CONSUMERS POWER COMPANY
MIDLAND UNITS 1 AND 2
MASTER LIST OF COMMITMENTS TO NRC ON 10 CFR 50.54(f) RESPONSES
STATUS SORT: PARTS I AND 2

Bechtel Power Corporation
October 8, 1980

MASTER LIST OF COMMITMENTS TO NRC ON 10 CFR 50.54(f) RESPONSES

FIGURE 8

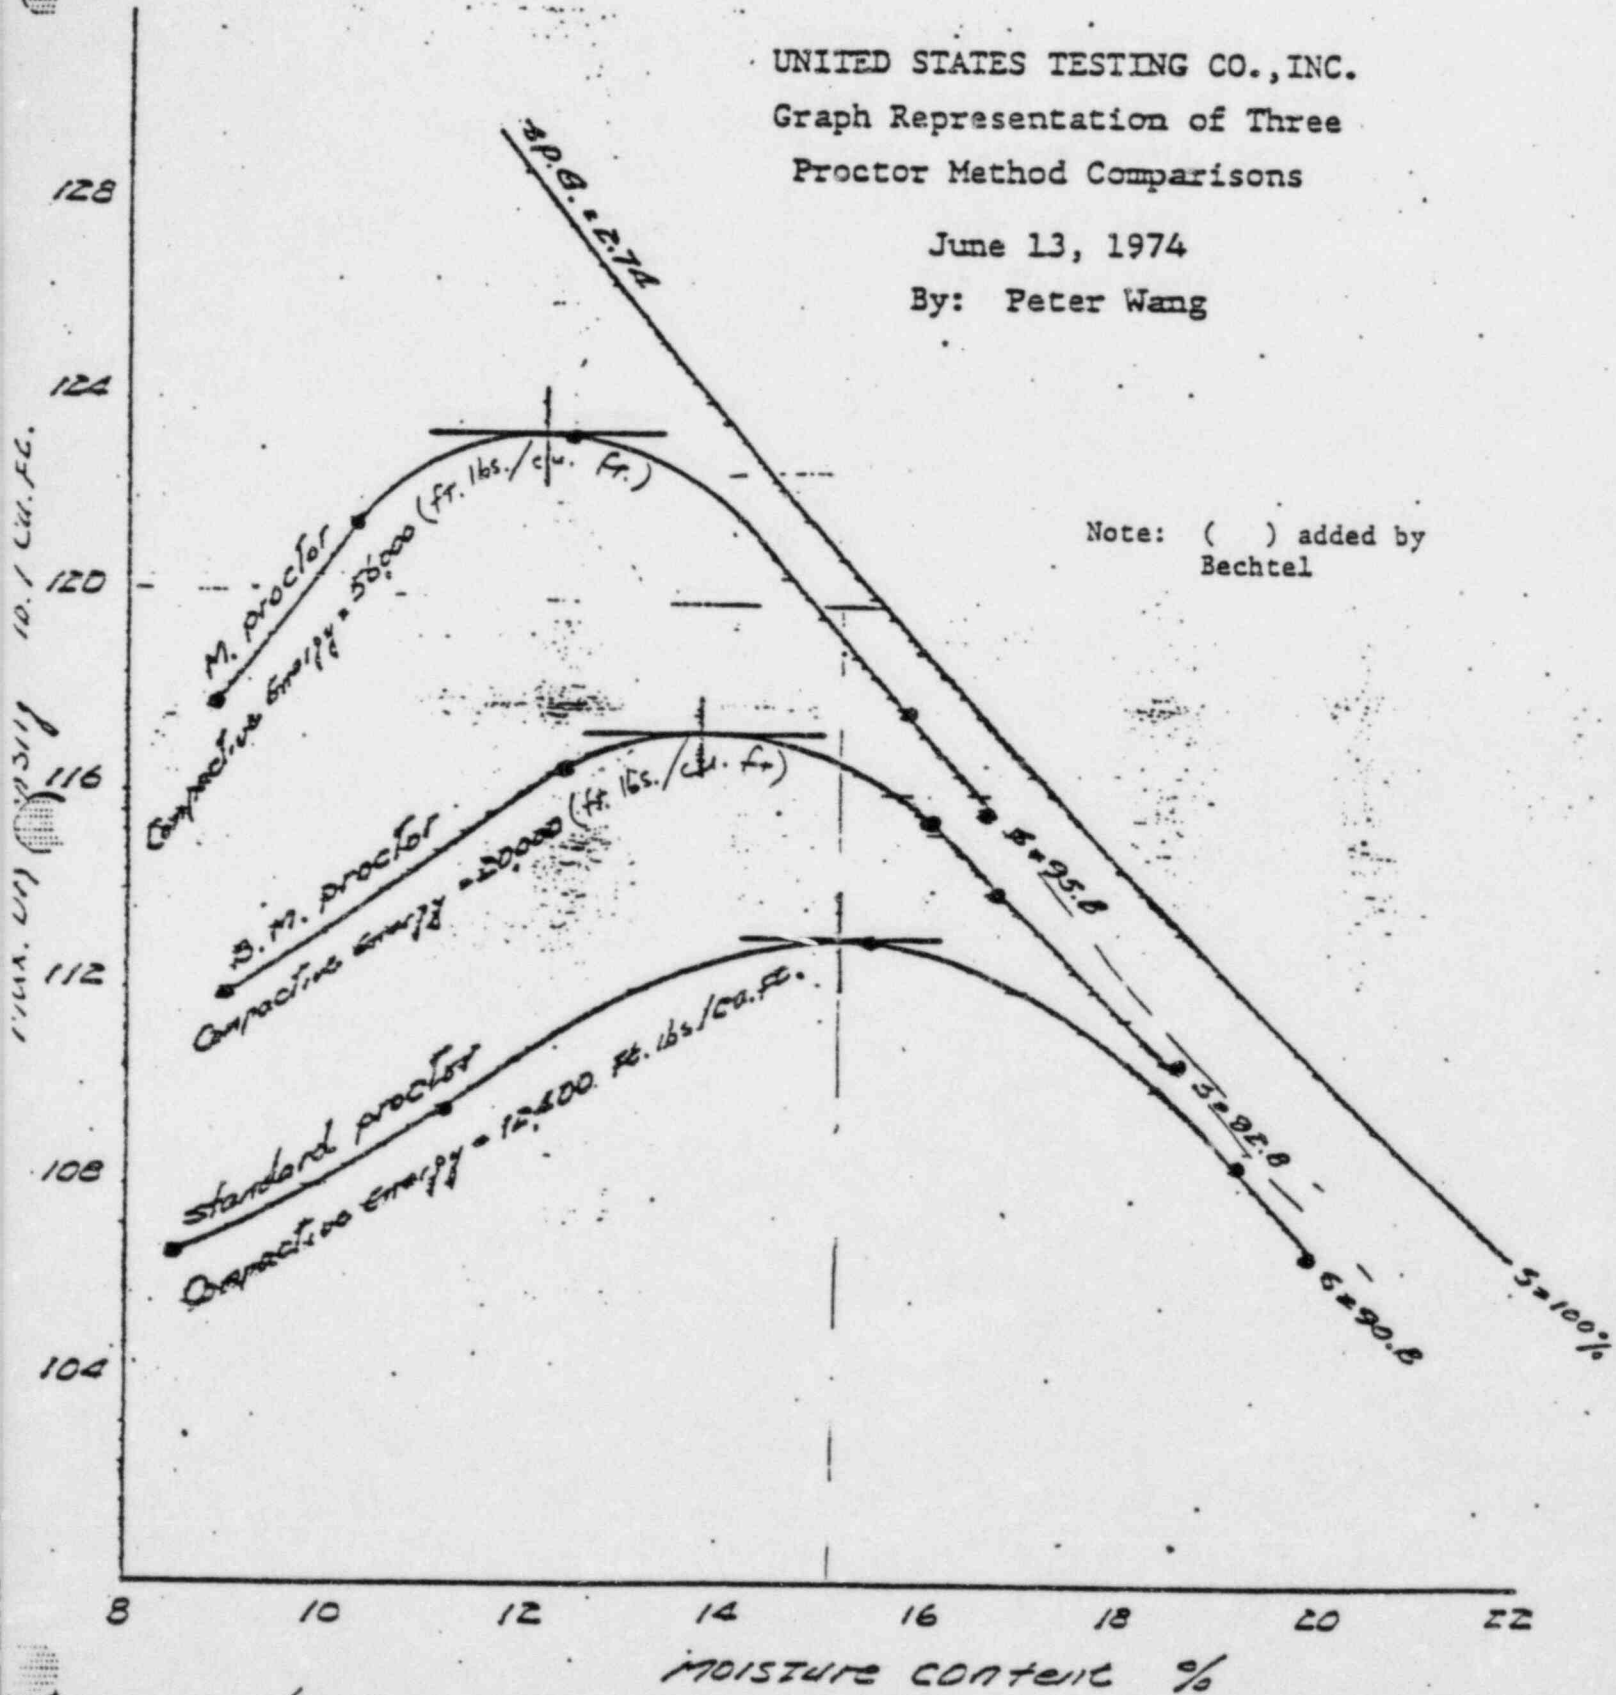
Also, referring to Figure 1 it would appear that soil density varied widely. Specifications called for compactive effort results as defined by ASTM D 1557 which is 56,255 ft-lb/ft³ energy. This was modified to a laboratory test compactive effort of about 20,000 ft-lbs/ft³ energy, often referred to as Bechtel Modified Proctor (BMP). Laboratory compaction test curves should be related to the same effort as that called for in the field for use in comparing with field density tests to determine percent compaction. According to plots of field data shown on Figure 1, density varied from about 108 lb/ft³ to about 130 lb/ft³. It is doubtful that the soil classification or other properties would be similar for such a wide variation in density. It is noted that 100 percent of modified Proctor (ASTM D 1557) which is difficult to obtain, is rated at 56,255 ft-lb/ft³ energy. The curve plotted on Figure 1 is at about 20,000 ft-lb/ft³ energy. For comparative purposes it was determined by U. S. Testing in 1974 that 100 percent of specified effort (20,000 ft-lb/ft³) is approximately equal to 95 percent of the maximum density as determined by ASTM D 1557 (56,255 ft-lb/ft³) Reference Figure 8.

FIGURE 9

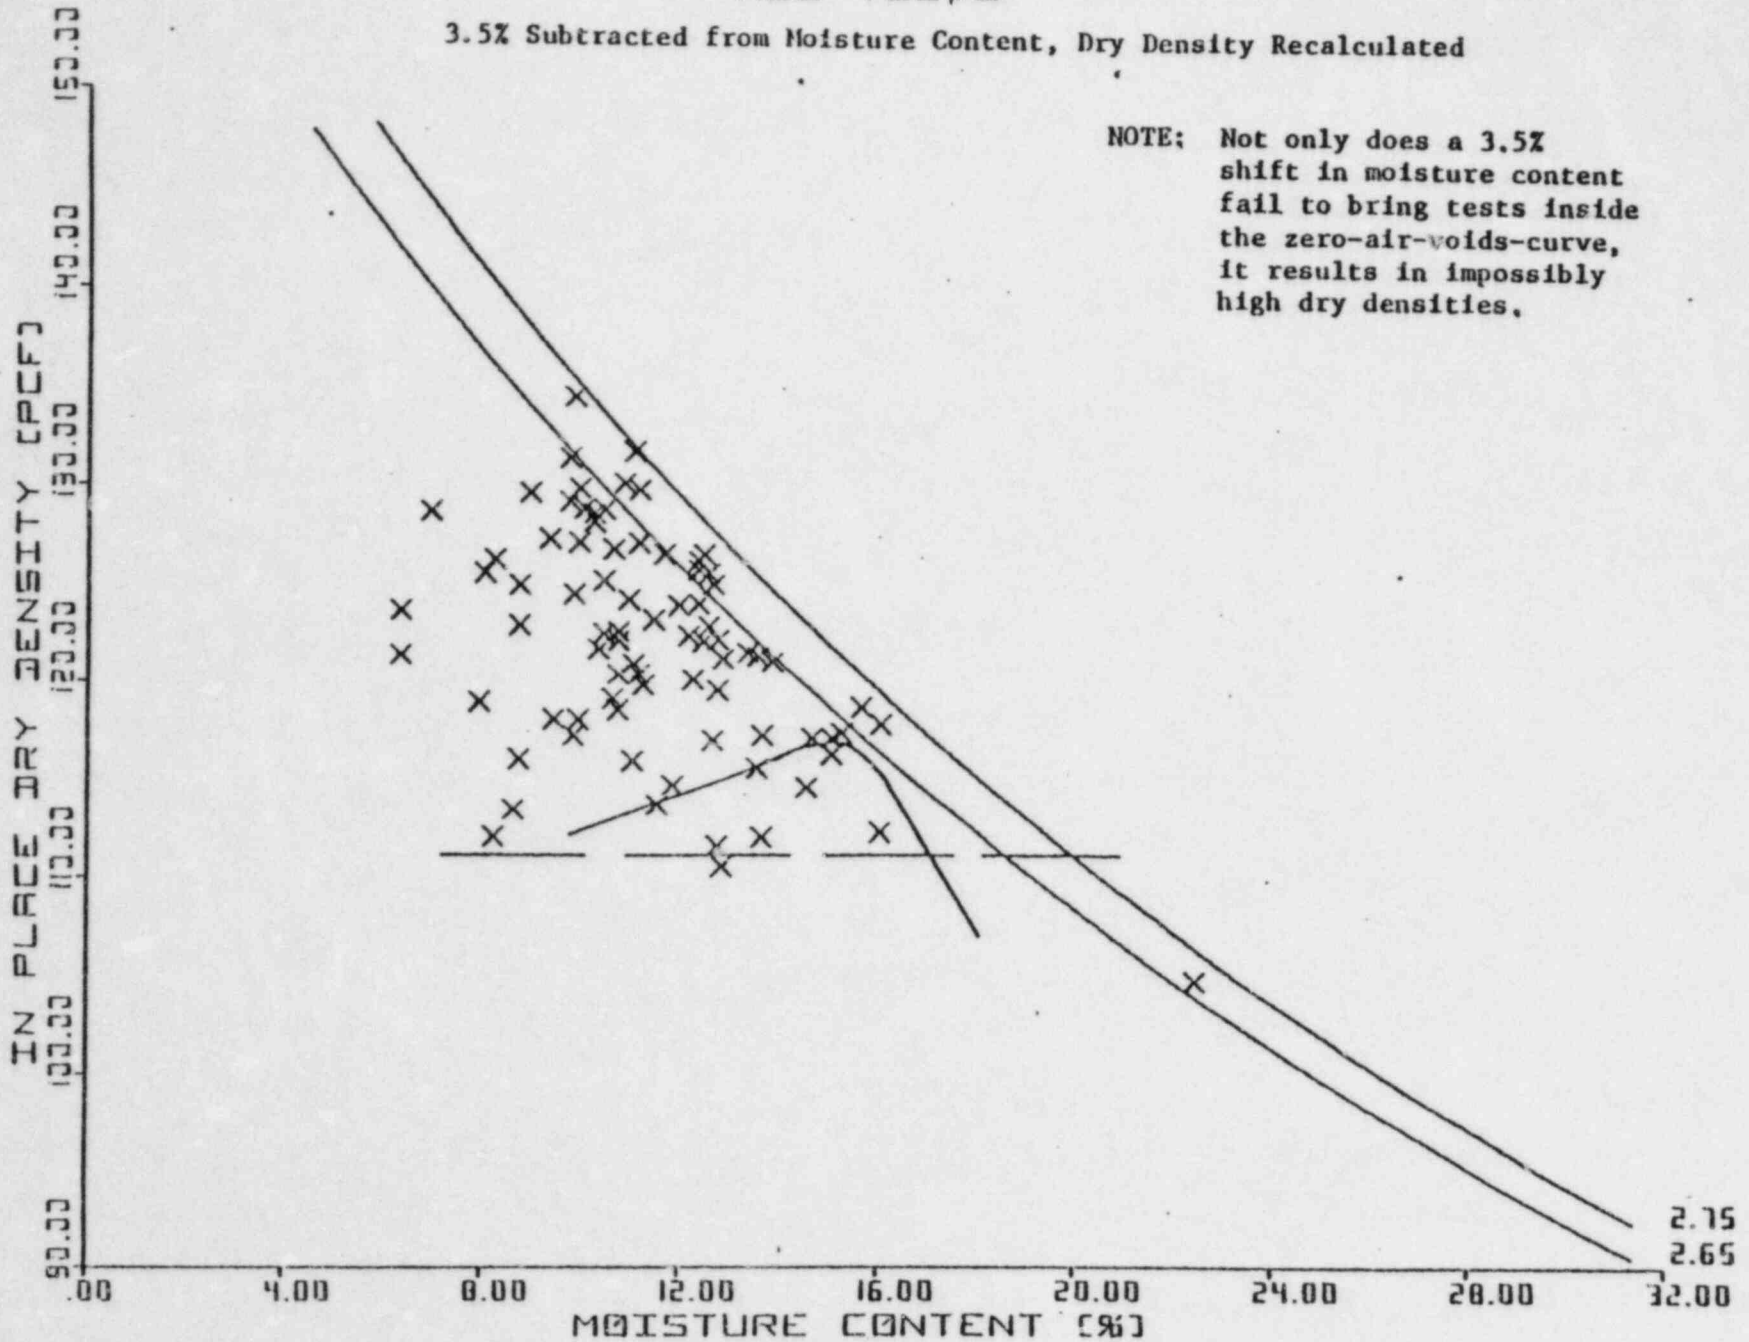
NOTE: Not only does a 3.5% shift in moisture content fail to bring tests inside the zero-air-voids-curve, it results in impossibly high dry densities.

Contrary to the assumption regarding figure 9 with its "impossibly high dry densities" current test data closely resembles this graphical representation.

FIGURE 10
 CHANGE IN RELATIVE DENSITY SCALE FROM DRY TO WET METHODS
 OF OBTAINING MAXIMUM DENSITY, BASED ON RECENT LAB RESULTS

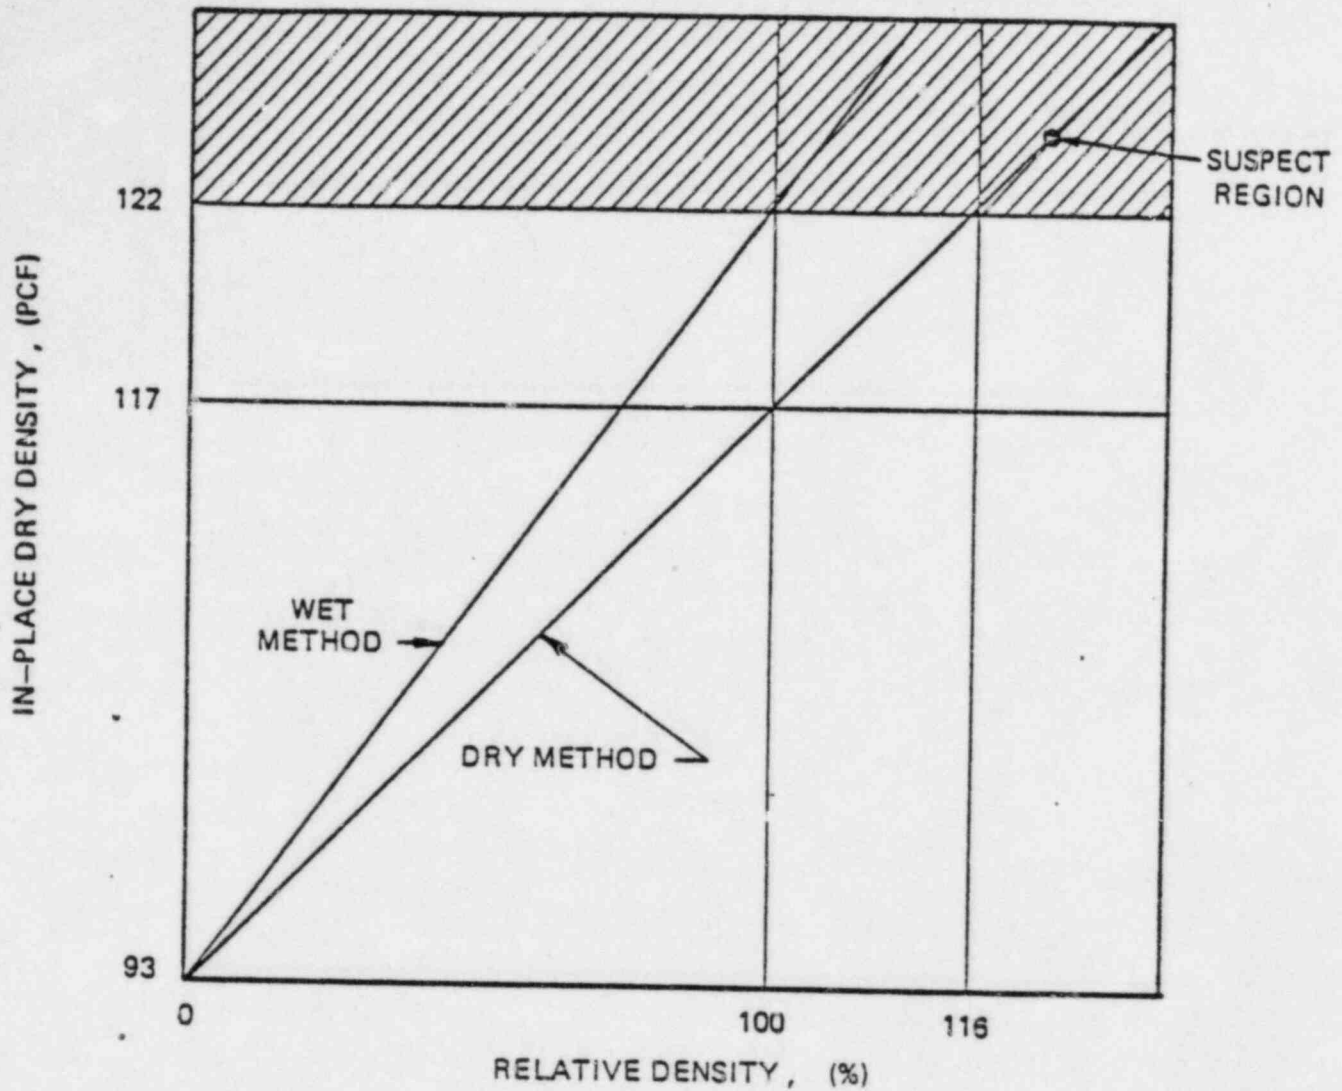
NOTE: VALUES FOR DRY DENSITY ARE TYPICAL OF A RANDOM FILL SAND. ANY TESTS SHOWING MORE THAN 117% RELATIVE DENSITY WOULD BE SUSPECT IN THIS EXAMPLE. STRUCTURAL SANDS TEND TO SHOW ONLY 2 OR 3 PCF INCREASE IN MAXIMUM DENSITY AND THUS RESULTS AT MUCH LOWER RELATIVE DENSITY WOULD BE SUSPECT, SAY 105 - 110 PERCENT
